**Government of India,
Ministry of Railways,
Research, Designs & Standards Organisation
Manak Nagar, Lucknow – 226 011**

Modification Sheet No. ELRS/MS/0272, Rev 'O'

Provision of brass ferrule in place of aluminum ferrule on roof bars.

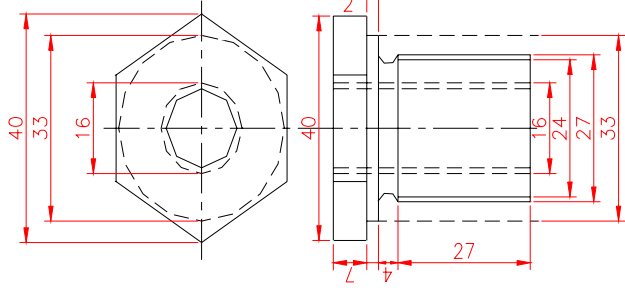
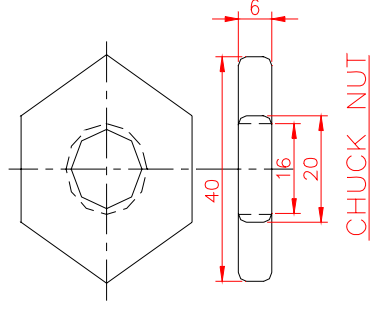
There are a number of cases of flashing, over heating and melting of aluminum ferrule in roof bars. As a result, unscheduled attention is required for flashed/overheated roof bars at knife contact mating with tube and ferrule.

To overcome the above problems, provision of brass ferrule with increased collar diameter has been made in place of existing aluminum ferrule.

Roof bars ferrule and check nut are to be produced/manufactured made of/from high tensile brass (IS 304-81) as per enclosed drawing.
